PJM Manual 14D:

Generator Operational Requirements

~~Revision: 59~~ Revision: 60

Effective Date: ~~September~~ October 1, 2022

Exhibit XXX. An example of real-time data and account metering requirements for a Mixed Technology Facility, including measurement points. This facility is 75 MW or larger and

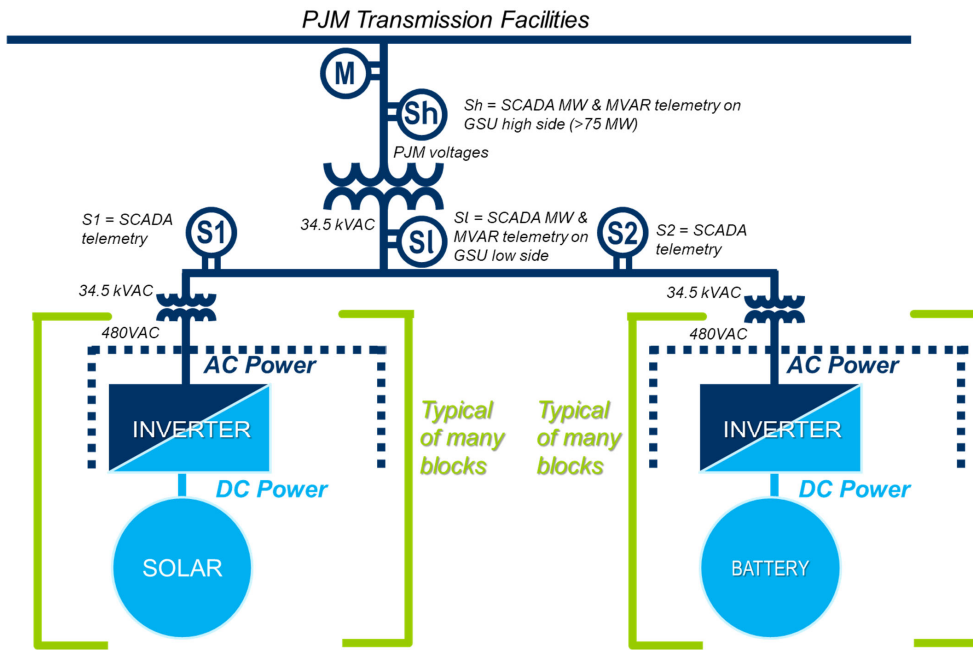
Exhibit XXXXX below illustrates an example of a Mixed Technology Facility with a solar resource and an Energy Storage Resource, each participating separately in markets as a Co-Located Resource. In this example, all of the energy measured for the Mixed Technology Facility at "M" across an interval (e.g., 5 minutes) is split between the solar resource and the Energy Storage Resource pro rata according to the power measured at S1 (which measures all of the solar production) and at S2 (which measures all of the storage power flows) integrated over the interval.

participates in PJM markets as a single Hybrid Resource. More or fewer measurement points may be required depending on circumstances; see Mixed Technology Facility business rules immediately above for more detail.

Exhibit 15: Example of inverter-based AC-coupled open-loop Hybrid Resource with 100 MW solar and 40 MW battery.

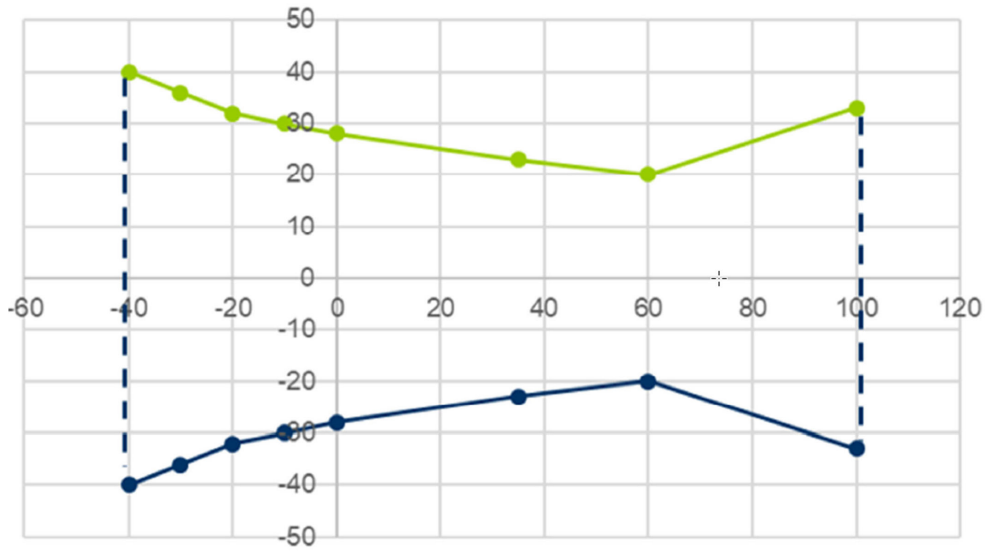
- 9.12. For a Hybrid Resource, the composite reactive capability curve shall represent the most conservative capability of the combined Generating Facility at each net MW injection point. See examples in Exhibits 15 & 16 below.
